RECALL 20V799 / 2020-630 REMEDY INSTRUCTIONS

Make(s): PUMA TRAVEL TRAILER
Model(s): PUT26RBSS (XLE LITE)
Model Year(s): 2021

Concern:
The exterior cooktop may be stowed and the exterior door may engage one of the two latches with the LPG line still connected to the cooktop.

FIGURE 1

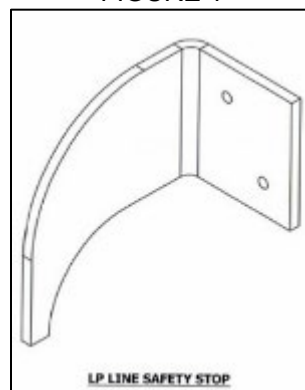
STEP 1: ORDER THE PARTS KIT FROM PUMA 425 XLE LITE AND RECEIVE THE "LPG LINE SAFETY STOP" (FIG. 1);

FIGURE 2

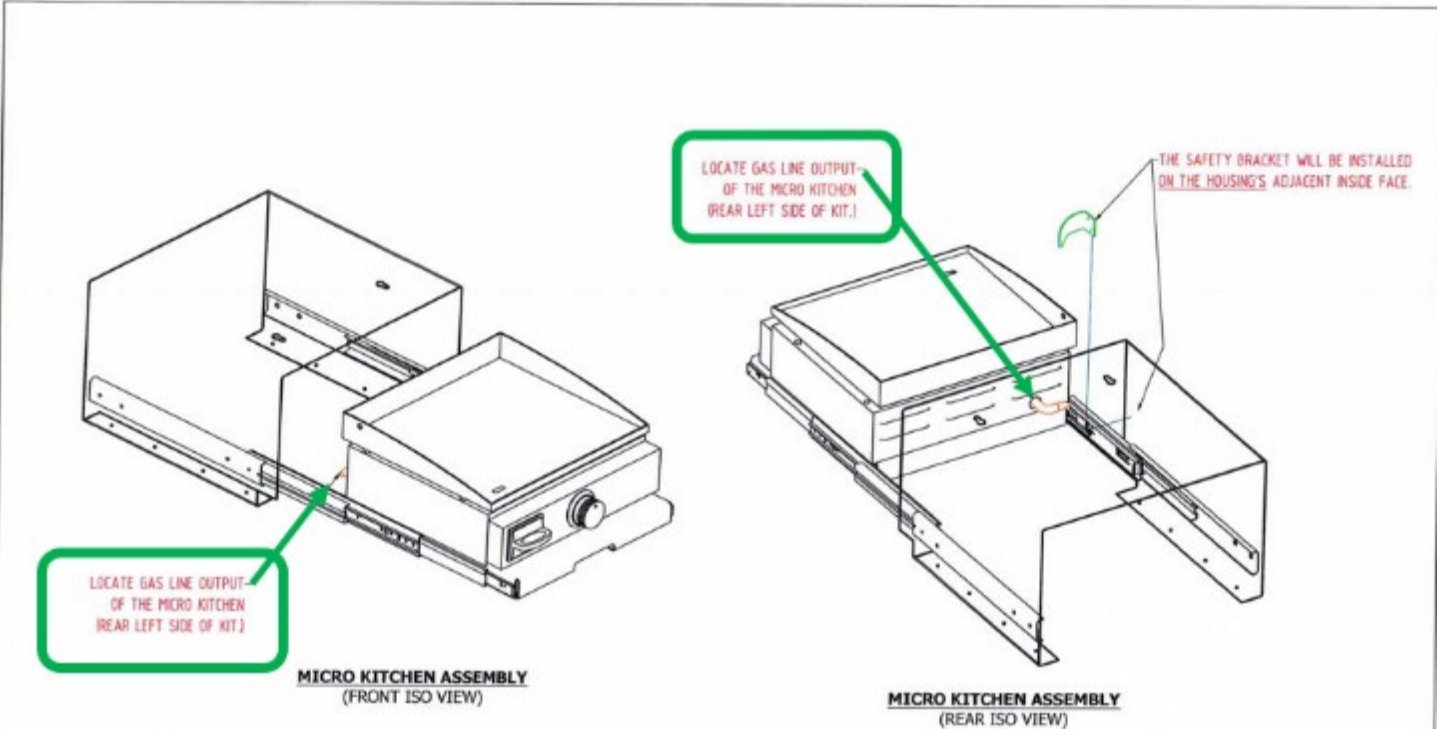
STEP 2: LOCATE THE LPG LINE OUTPUT OF THE EXTERIOR MICRO KITCHEN (FIG. 2);

LOCATE THE LP OUTPUT LINE OF THE PHYSICAL GRIDDLE

NOTE: THIS WILL BE THE SIDE OF THE HOUSING THE BRACKET WILL BE MOUNTED TO

FIGURE 3

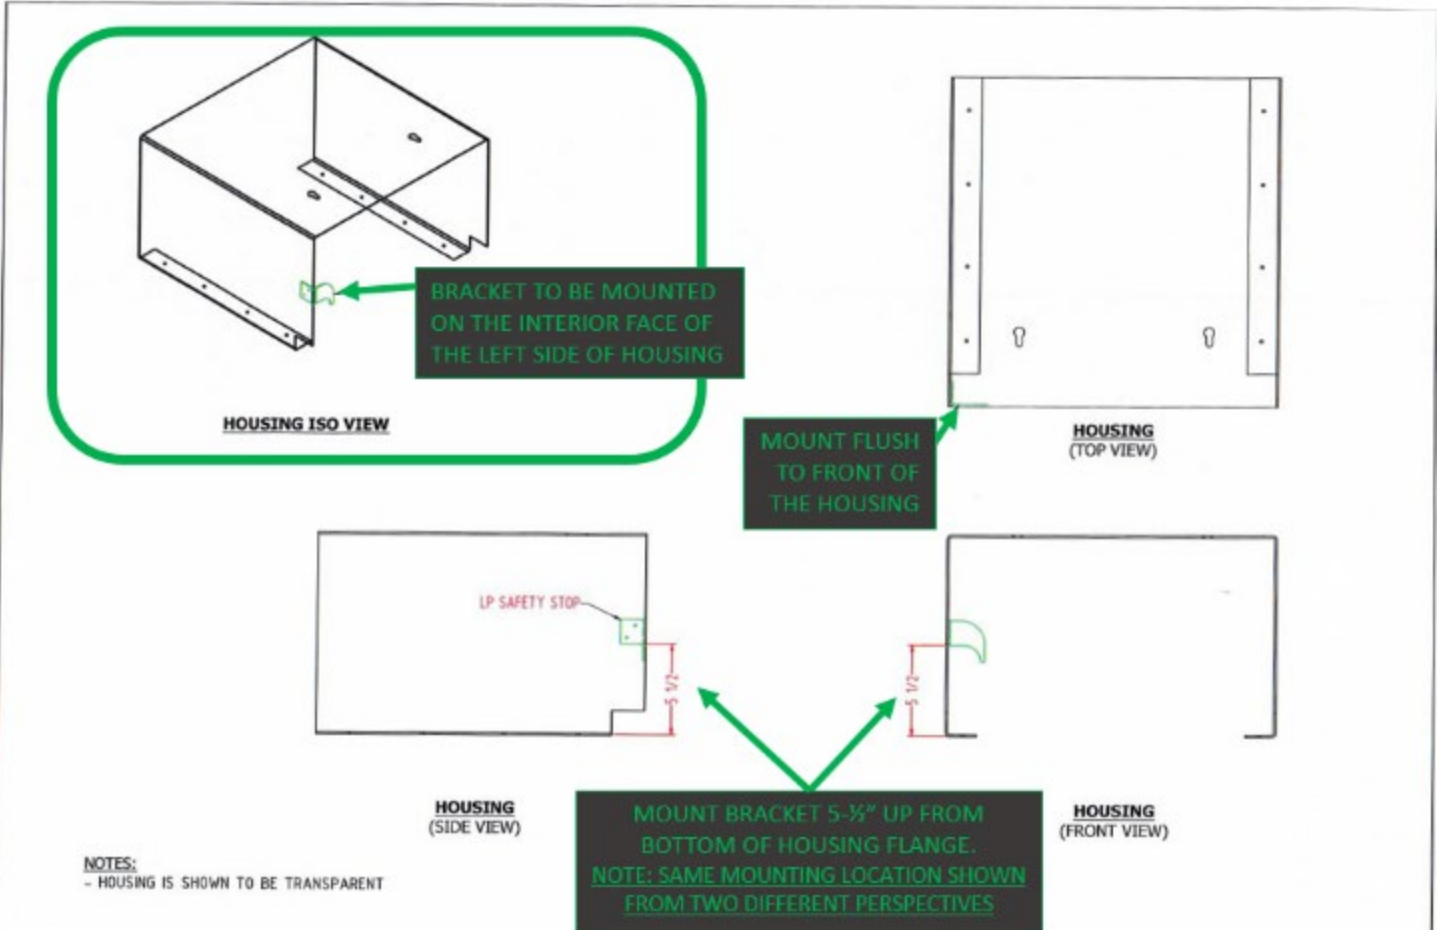
STEP 3: LOCATE THE LPG LINE SAFETY BRACKET PER THE DIMENSIONS AND LOCATION LISTED IN FIGURE 3 AND MARK THE HOLES ONTO THE MICRO KITCHEN HOUSING;

STEP 4: DETERMINE THE APPROPRIATE SIZE RIVET THAT MATCHES THE HOLES IN THE LPG LINE SAFETY STOP;

STEP 5: DRILL THE APPROPRIATE SIZE HOLES ON THE HOLE MARKS ON THE MICRO KITCHEN HOUSING THAT WILL LOCATE THE LPG LINE SAFETY STOP;

STEP 6: CHECK FOR CORRECT ORIENTATION OF THE LPG LINE SAFETY STOP AND RIVET INTO PLACE AND ENSURE THE INSTALLATION OF THE BRACKET IS SECURE AND NOT LOOSE;
